9-D-22-HZ
APPLICATION FOR CERTIFICATE OF APPROPRIATENESS

2020 Emoriland Blvd. 37917
Fairmont-Emoriland NC

Staff Report

Revised proposal for new secondary structure (accessory dwelling unit) submitted as overall new construction project at 2020 Emoriland Boulevard. This application does not contain revisions to the primary structure or overall site plan. The ADU is approximately 24' by 20', with an additional 6' roof overhang on the front (northwest) elevation. The ADU features a shed roof clad in prefinished metal roofing, 10" horizontal fiber cement siding, and a cast-in-place concrete foundation, all to match the primary structure. On the ADU's façade, a full-light wood door is adjoined by multiple single-light, aluminum-clad wood windows to the right. A single light picture window is located on the upper level of the right side and a secondary door is located on the left.

ADU / Carport North Elevation
Scale: 3/16" = 1' - 0"

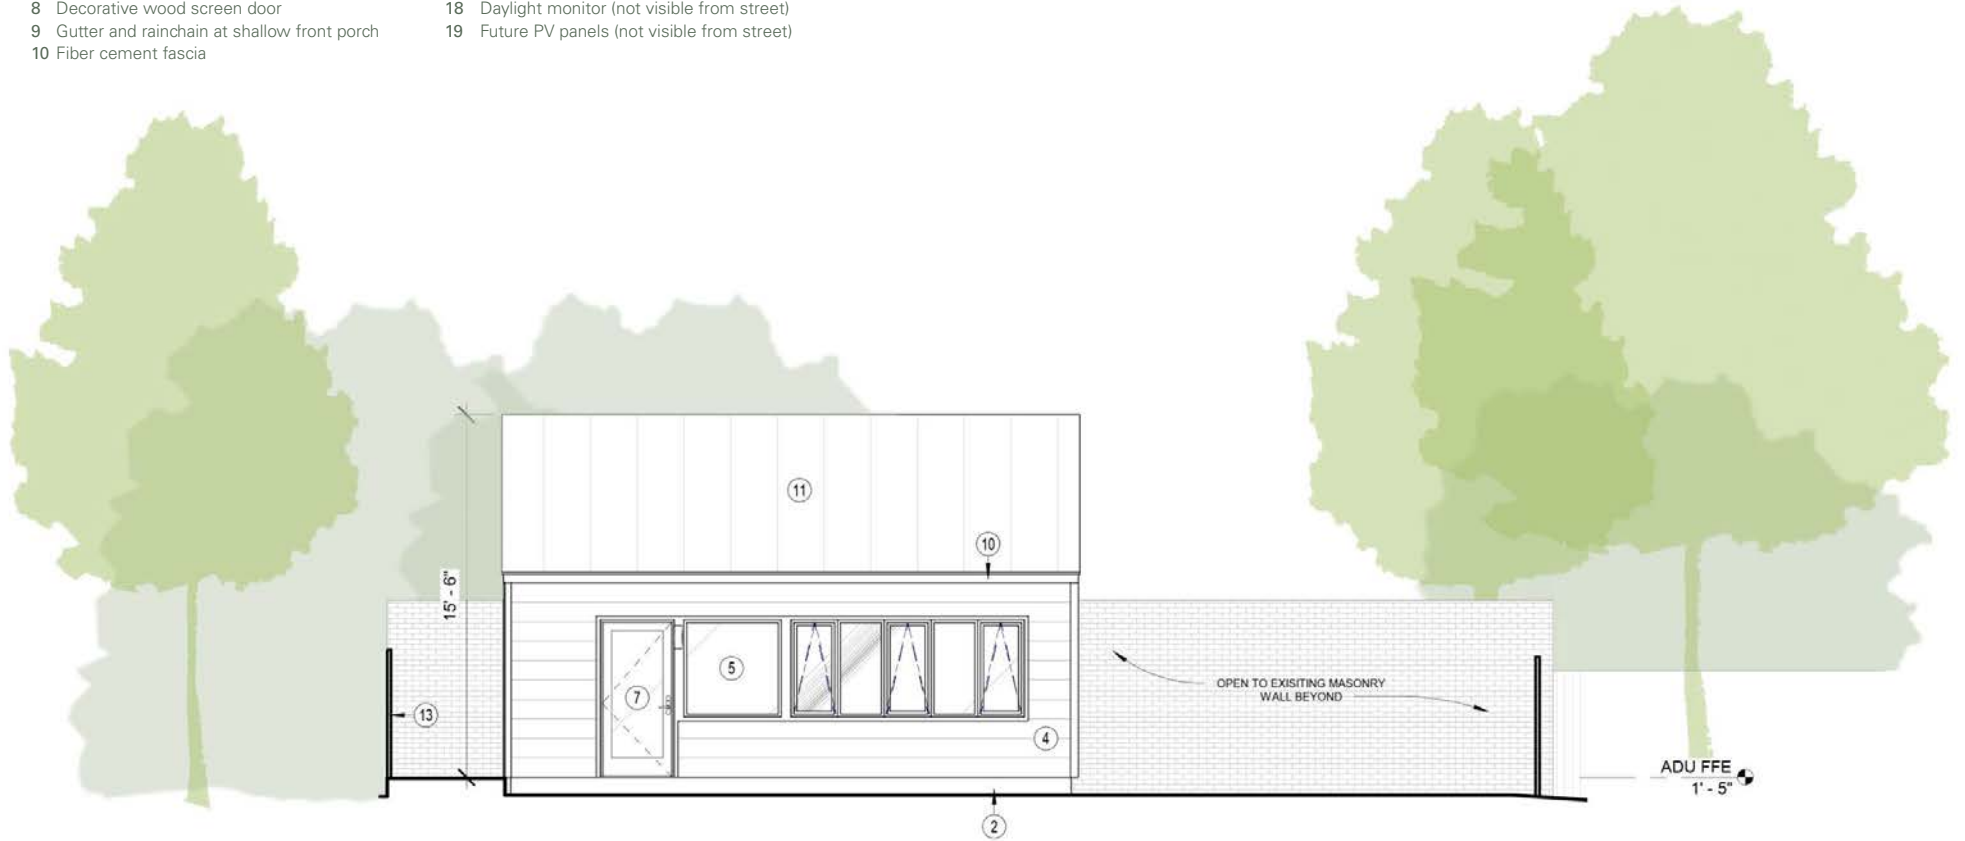
2. The primary issue with the accessory dwelling unit was with regards to the base zoning code, and the ADU's shared roofline with a carport. With a connected roof, the ADU and carport were defined as one accessory structure per the City zoning code, and exceeded the maximum building coverage for a single accessory structure on the lot. This issue has been addressed by removing the carport.

3. At approximately 508 sq. ft., the proposed ADU does not exceed 40% of the primary dwelling's gross floor area or the maximum building coverage for an accessory structure. The ADU meets the relevant criteria of the City zoning code. The ADU is modest in scale and massing.

4. The new ADU will be very minimally visible from the public right-of-way, if visible at all, due to the proposed placement immediately behind the primary house (towards the left side of the lot) and the construction of a fence on the house's right side. Placement of the ADU is appropriate.

5. The ADU is compatible with the overall style and materials of the new construction primary residence. The ADU adapts the house's contemporary interpretation of a Minimal Traditional style to an accessory building. Despite being relatively small in size, especially on the side elevations, each elevation features transparency via a window, door, or a combination of the two.

Staff recommends approval of Certificate 9-D-22-HZ (secondary submission) as submitted.
